REDTAIL RANCH

FINAL PLAT

LETTER OF INTENT – FINAL PLAT

DECEMBER 2018

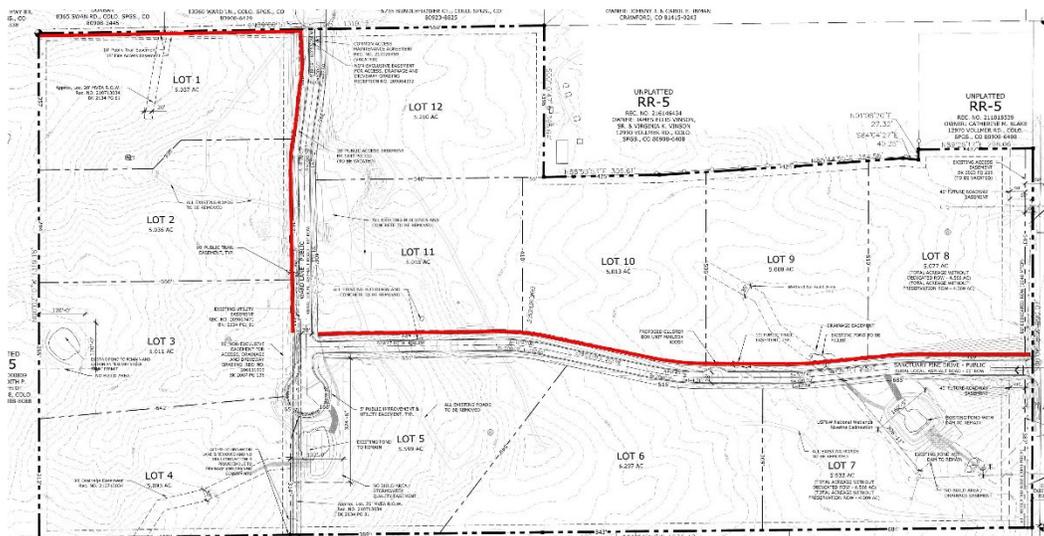
Add permanent sediment control for east end of Sanctuary Pine Dr.

Language added to LOI. Sediment control is addressed in CDs.
